A47 North Tuddenham to Easton

Scheme Number: TR010038

Volume 9 **9.22 Applicant's Responses to Deadline 4** **Comments**

9.22 APPLICANT'S RESPONSE TO DEADLINE 4 COMMENTS

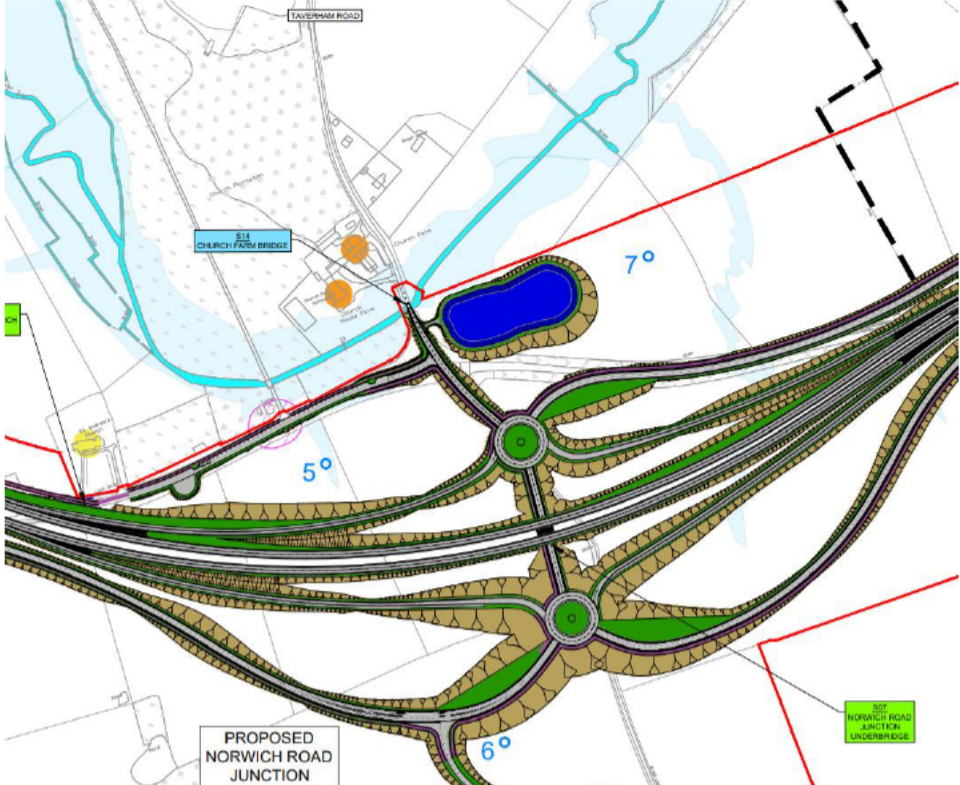
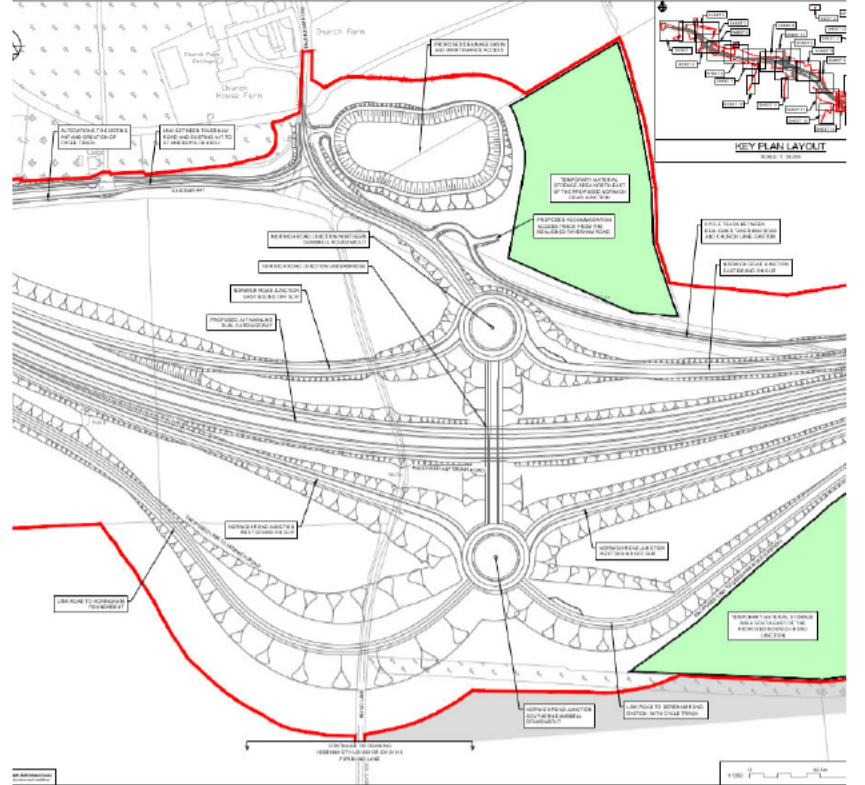
<p>Hearing 2. Item 6 Heritage - When the heritage bodies asked for the Norwich Road junction to be moved 150m further east to avoid impact on the setting (and deceased souls) of Honingham Church, did HE ever equally consider the impact on the (living) souls now facing directly onto the new junction position?</p>	<p>The Applicant has considered the impacts and, if required, mitigation for local residents in the following application documents:</p> <ul style="list-style-type: none"> • ES Chapter 5 Air Quality (APP-044). • ES Chapter 7 Landscape and Visual Effects (APP-046). • ES Chapter 11 Noise and Vibration (APP-050). • ES Chapter 12 Population and Human Health (APP-051). <p>It is important to note that the Scheme is replacing the existing A47 with a new dual carriageway upwards of 200m south of the existing A47, away from properties near Honingham Church and on Taverham Road. In addition, as illustrated below the relocation of the Norwich Road Junction further east post Statutory Consultation feedback also moved the junction further from properties near Honingham Church and on Taverham Road.</p> <p>Noise mitigation is embedded into the Proposed Scheme in this region in the form of a low noise road surface on the proposed mainline dual carriageway.</p> <p>Sheet 14 of the Environmental Masterplan, Rev 2, (REP3-016) also demonstrates provision of woodland and shrub planting north of Norwich Road Junction to supplement the retained mature trees north of the existing A47, as shown below, provide a visual screen to properties near Honingham Church and along Taverham Road.</p>  <p>Annex A to this document presents two cross sections from properties along Taverham Road looking towards the Scheme to show how the planting would screen views.</p>

Comment	Applicant Response
 <p>Norwich Road Junction at Statutory Consultation in 2020 (shown in A47 North Tuddenham to Easton - Scheme Plan, available in the 2020 Consultation Documents available at: [REDACTED])</p>	 <p>Norwich Road Junction in DCO application design Shown on Sheet 14 of the General Arrangement Plans, Rev.1 (REP3-002)</p>
<p>It is understood locally that the field immediately west of the Blind Lane / A47 junction is the location of the original old village of Honingham, apparently abandoned as a response to the Black Death. Were HE's archaeologists aware of this and did they uncover any findings to support this? Is there any interesting research here which might be shared with Honingham Parish?</p>	<p>These areas were surveyed by geophysical survey and evaluation trenching, as reported in ES Appendices 6.2 and 6.3 (APP-086 to APP-088). The results of site visits, geophysical survey and trial trenching have been used to inform the assessment of archaeological potential. Norfolk County Council was consulted in relation to the design of archaeological evaluations and archaeological mitigation proposals. The areas of archaeological potential were agreed with Norfolk County Council.</p> <p>The area in question is within archaeological Zone 5, described in paragraph 6.7.49 of ES Chapter 6 Cultural Heritage (APP-045) and paragraphs 6.3.177-186 of ES Appendix 6.1 (APP-085).</p> <p>A strategy for appropriate dissemination of archaeological information will form part of the Written Scheme of Investigation (WSI) committed to under Action CH6 in table 3.1 of the Environmental Management Plan (APP-143).</p>

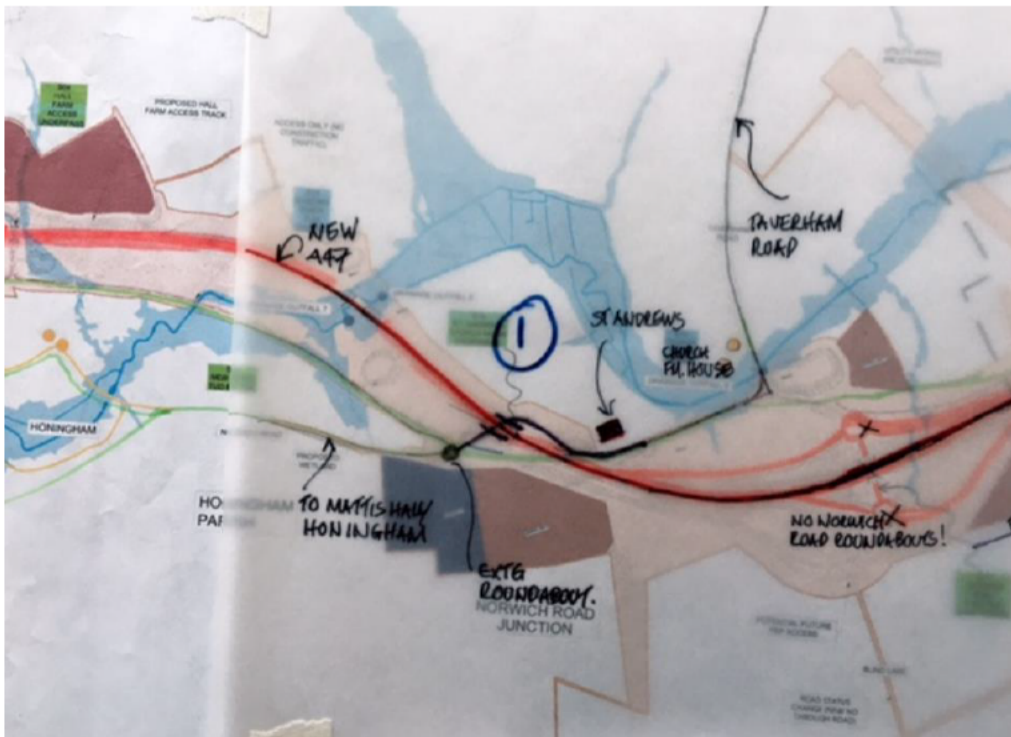
Comment	Applicant Response
	<p>Long-term change in road traffic noise, dB $L_{A10,18hour}$ (change over the 15 year period)</p> <p>Noise difference</p> <ul style="list-style-type: none"> ■ Greater than or equal to 10.0dB ■ 5.0 to 9.9dB ■ 3.0 to 4.9dB ■ Less than 3.0, more than -3.0dB ■ -3.0 to -4.9dB ■ -5.0 to -9.9dB ■ Less than or equal to -10.0dB
	<ul style="list-style-type: none"> □ DCO boundary — Proposed Scheme design - - Operational study area ● Significant beneficial noise effects ● Significant adverse noise effects ■ Noise important area
<p>Early in the consultation process, great concern was raised with HE about the potential loss of the dark skies in this area of countryside. A verbal assurance was received from the former HE Project Manager that the lighting of the Norwich Road junction would be limited to the underpass area and would be very low level. It seems that this may not be the case, as we learn (at the hearing) that the slip roads will also be lit. This makes the removal of the present (very bright) Easton roundabout lights almost irrelevant if this night sky pollution is to be transferred down the road to this new junction.</p> <p>Will HE share and discuss with Taverham Road residents the layout and design detail of the lighting proposals for the Norwich Road junction? We would like to see the proposals and have an opportunity to comment. We would like to see that information at this stage and not when/after it is built.</p>	<p>The ExA is directed to previous response on concerns about lighting of the Scheme and impact on dark skies in responses RR-017.2, RR-017.3 and RR-055.11 in the Applicant's Responses to the Relevant Representations (REP1-013).</p> <p>The impacts of lighting on the existing environment and proposed mitigation measures are assessed within ES Chapter 7 Landscape and Visual Effects (APP-046) and ES Appendix 7.7 Lighting Assessment (APP-095). Section 7 of ES Appendix 7.7 provides an analysis of the potential post construction light spill levels associated with the Scheme, to allow an assessment of the potential effects on sensitive receptors based on indicative locations for lighting columns.</p> <p>The Scheme is required to provide artificial lighting for safety on the approach to and through the proposed junctions, slip roads and associated roundabouts. The design of the Scheme lighting has been undertaken in accordance with:</p> <ul style="list-style-type: none"> • UK Design Manual for Roads & Bridges (DMRB) TA 501 – Road Lighting Appraisal • Institution of Lighting Professionals (ILP) Professional Lighting Guide PLG 02 - The Application of Conflict Areas on the Highway • BS5489-1:2020 Table A4, Lighting Classes for Conflict Areas. • Institution of Lighting Professional's Guidance Notes for the Reduction of Obtrusive Light, 2020 • Institution of Lighting Professional's Guidance Note 08/18 Bats and Artificial Lighting in the UK in 2018, developed in collaboration with The Bat Conservation Trust. <p>The Applicant has also designed the junction below the proposed A47 mainline in a cutting to minimise the impact of light spill.</p>

Comment	Applicant Response
<p>May I also ask whether you are satisfied that the apparent discrepancy I identified (between distances in text and drawing) in HE's DCO Draft (advised in my last submission) has now received an answer / correction?</p> <p>Notwithstanding my original Statement submission, I have noticed an apparent and worrying discrepancy between HE's text in their draft consent and their drawings. I would request that this be checked / queried by the Inspectorate and clarified by HE - and the text corrected as appropriate.</p> <p>Schedule 1, p6. Page 44 of the 167 page document posted on 12 October, Works No.47. HE appears to refer to taking control on Taverham Road for 270m north of the Tud bridge, but the HE drawings only outline the road up to the entrance to Church farm House - which is barely 20m north of the bridge. (270m beyond the bridge would take their works some way up past our own property - for what purpose?).</p>	<p>The Applicant acknowledges the comment and confirms the dDCO is to be amended to clarify 270m refers to distance of works length from the Norwich Road Junction to north of the bridge.</p>

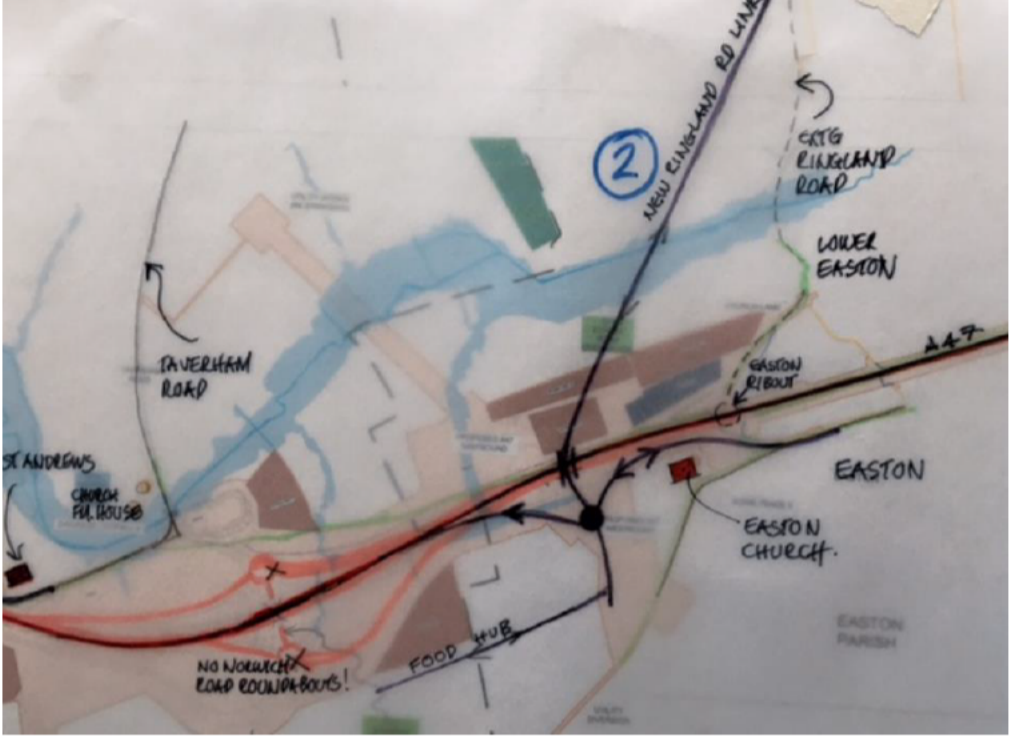
<p>2. Replace the current Ringland Road connection from Taverham to the A47 through Lower Easton with a short length of new road, skirting just west of the</p>	<p>As demonstrated in the above responses within this table, the Applicant's Scheme will reduce traffic along Taverham Road when the</p>

Comment	Applicant Response
<p>Lower Easton properties. Connect to the A47 heading west / leaving east carriageways only - no Norwich bound slips - with simplified bridge over the A47 and smaller roundabout on the south side (west of Easton church) to connect both Easton and the Food Hub to the westward A47. This seems already to be on land acquired by HE for their compounds, so one assumes must avoid sensitive sites. Remove the Norwich Road junction and A47 connection entirely at Taverham Road. Sketch 2 attached.</p> 	<p>Scheme is operational. The Applicant has also proposed a mitigation measure in a no NWL scenario that will also reduce traffic along Taverham Road compared to both the 2015 baseline and 2025 Do Nothing scenarios.</p> <p>In line with the Scheme's objective to provide a more free-flowing network, the existing Easton roundabout needs to be removed. The location of the new Norwich Road junction at Easton was determined based on the requirement for a fully grade separated junction, whilst taking into account existing constraints.</p> <p>The Interested Party's alternative is not feasible for several reasons:</p> <ul style="list-style-type: none"> • Does not provide a connection to users south of the A47, which would result in increased traffic travelling through Easton village to join the strategic road network at the Longwater junction. • Likely to increase harm to the setting of the Grade 1 listed St Peter's Church compared to the Scheme design. • Does not account for availability of existing sideroads and accesses, to avoid an over-engineered design that unnecessarily requires avoidable private land acquisition. • Additional environmental impacts on sensitive receptors, such as the need for another bridge crossing over the River Wensum chalk river. • Overlaps with the consented Orsted cable route. • Does not avoid loss of land within the approved Food Enterprise Zone development. • Commits public funds to providing a connection to a private development where there is no such requirement, as set out in Section 9.3 of the Scheme Design Report, Rev.1 (AS-009). • Requires retention of the existing A47 east-west connection between Taverham Road and Honingham roundabout. This would increase the potential harm to the Grade II* listed setting of St Andrew's Church due to the landscape, visual and noise impacts associated with the raising of the dual carriageway mainline over the existing A47 south and west of the church.

SOURCE: Appendix 13.1 Flood Risk Assessment, Part 1 of 2 (APP-124)

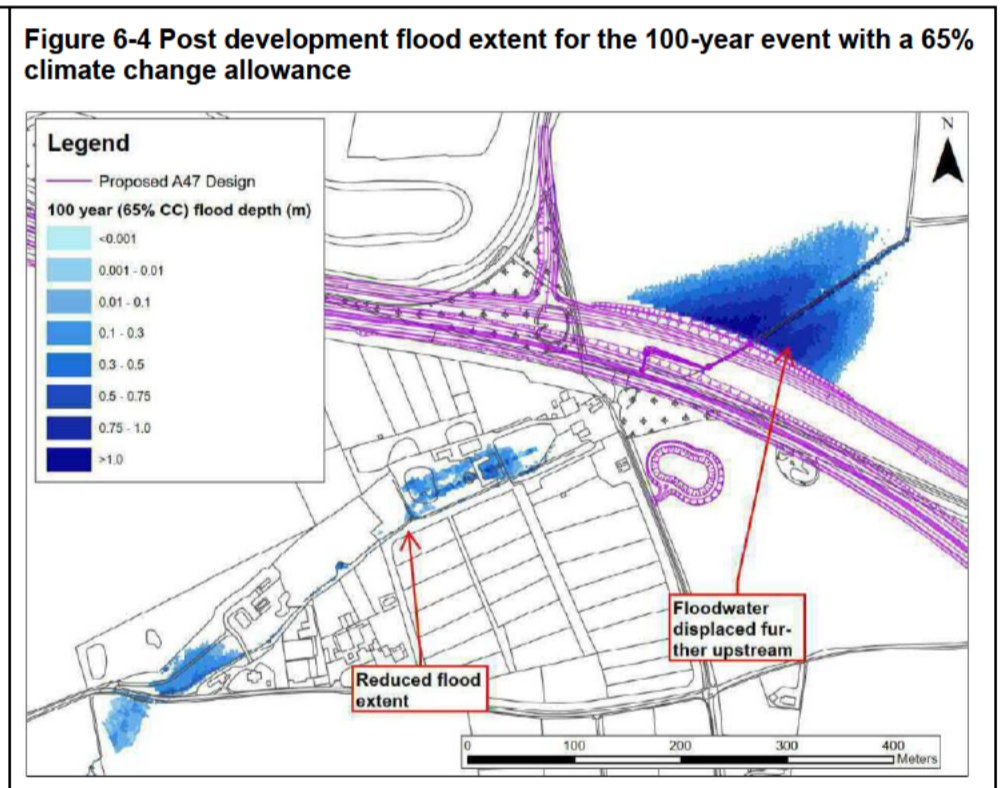
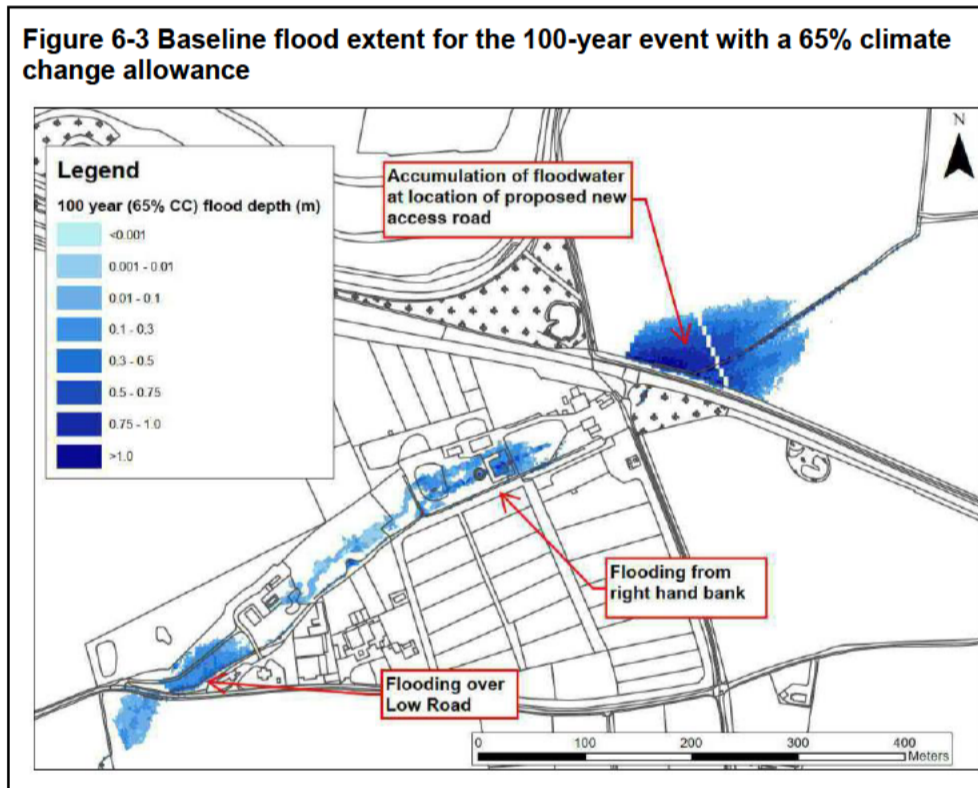
<p><u>Letters previously served addressed to me regarding A47 dualling project</u></p> <p>At today's hearing Jonathan Bower offered to supply a schedule of all letters served to me regarding this project since its conception, bearing in mind that the first communication I received was from Highways England on 06/05/21. I would like to accept his offer please and look forward to receiving the schedule.</p>	<p>The Applicant confirms a schedule of correspondence records has been issued to Mr Wright.</p>
